McDonnell Douglas Helicopter Company SERVICE INFORMATION NOTICE

INSTALLATION OF NI-CAD BATTERY TEMPERATURE SENSING MODIFICATION KIT, PN M50037 OR M50038

369H Helicopter Serial No. 0001 thru 0005 369HE Helicopter Serial No. 0101E thru 0215E 369HS Helicopter Serial No. 0001S thru 0510S 369HM Helicopter Serial No. 0001 thru 0004; 0005M thru 0230M; 0233M thru 0235M

NOTICE NO. HN-62 DATE 6 AUGUST 1973 PAGE 2 OF 11

Figure 1. Installation - NI-CAD Battery Temperature Sensing Modification Kit, PN M50037 (Sheet 1 of 2)

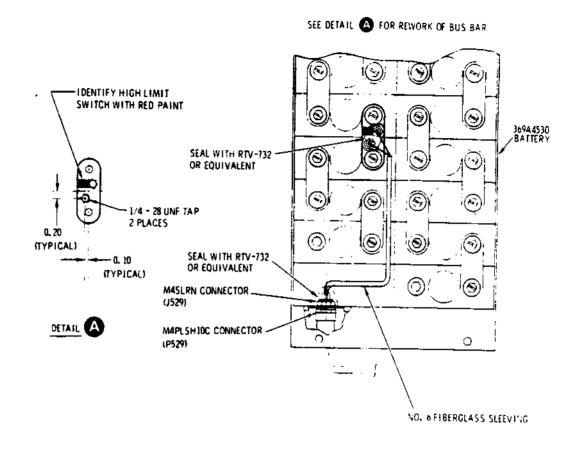
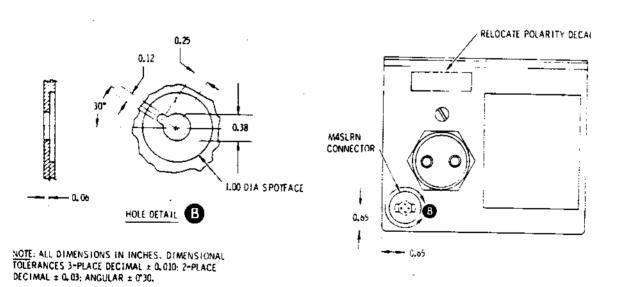
- d. Remove battery cover and discharge the battery, as applicable.
- e. Relocate polarity decal to upper side of battery case; carefully drill hole and cut keyway in battery case and spotface per dimensions shown (see Detail B, Figure 1 for M50037 Kit; see Detail B, Figure 2 for M50038 Kit).

- f. Remove bus bar shown; drill and tap bus bar two places (see Detail A, Figure 1 for M50037 Kit; see Detail A. Figure 2 for M50038 Kit).
- g. Paint red stripe on bus bar to identify Hi-Limit switch (160F sensor); reinstall bus bar.

- 3. Position and nest 369H2075-11 housing box assembly on instrument panel center fairing as shown in Figure 1. Match drill two 0.187 inch diameter attachment holes through box and center fairing. Match drill 0.380 inch diameter wiring hole through box and center fairing. Install box assembly on center fairing with two screws and washers.
- 4. Install red and amber warning lights on -11 housing cover as shown.
- 5. Route leads of warning light wiring harness through center fairing and box assembly; solder wire leads and jumper wire to lamp terminals as shown (see Figure 1 and wiring diagram).
- 6. Install engine out warning horn unit on housing cover; route existing horn wiring through box assembly and center fairing. Install cover on box assembly.
- 7. Reconnect horn wiring; reinstall instrument panel center fairing.

Figure 1. Installation - NI-CAD Battery Temperature Sensing Modification Kit, PN M50037 (Sheet 2 of 2)

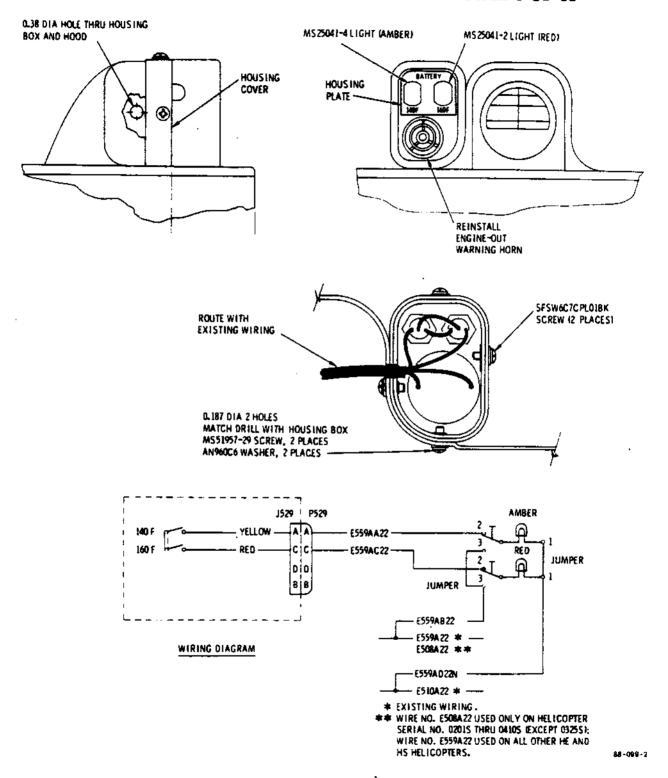
- 2. Install red and amber warning lights with housing plate on instrument panel, or on housing cover, as applicable.
- 3. Route leads of warning light wiring harness to instrument console or through box assembly; solder wire leads and jumper wire to lamp terminals as shown.
- 4. Install cover on box assembly, as applicable.
- n. Perform the following for M50038 Kit installation only.

Figure 2. Installation - NI-CAD Battery Temperature Sensing Modification Kit, PN M50038 (Sheet 1 of 2)

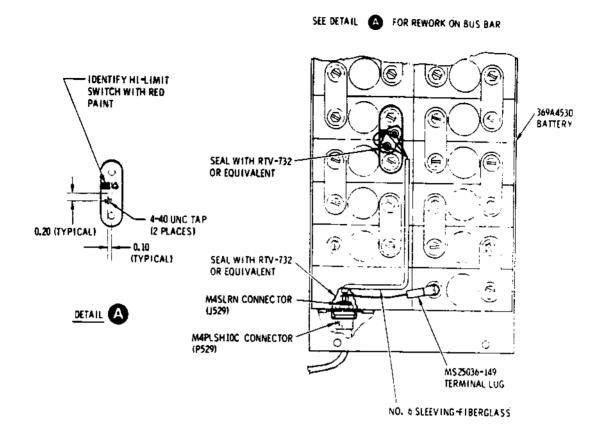
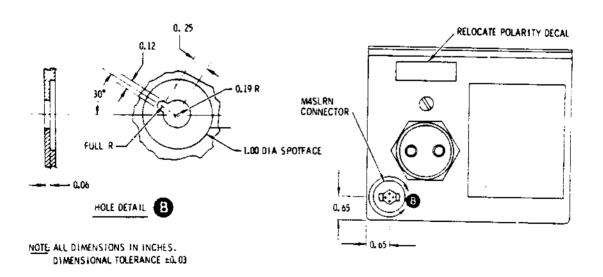
1. On caution light assembly on instrument console, remove existing left-hand "SPARE" window. Remove lettering from window using fine emery. Install M50038-3 decal between window and transparent lens and reassemble to window frame (see View C, Figure 2).

- 3. Crimp sockets to wiring leads of wiring harness and connect to terminals of master caution control as shown (see Figure 2 and wiring diagram).
- o. Route warning light wiring harness with existing wiring to battery area; secure harness to structure with tie-straps as required.

Figure 2. Installation - NI-CAD Battery Temperature Sensing Modification Kit, PN M50038 (Sheet 2 of 2)

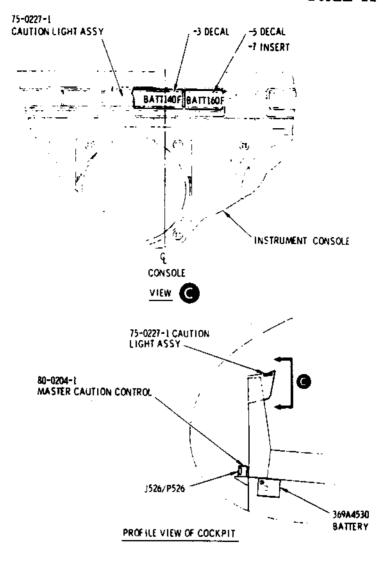
- 2. Remove existing right-hand "SPARE" window and discard. Install M50038-5 decal between M50038-7 insert and transparent lens and reassemble to window frame.
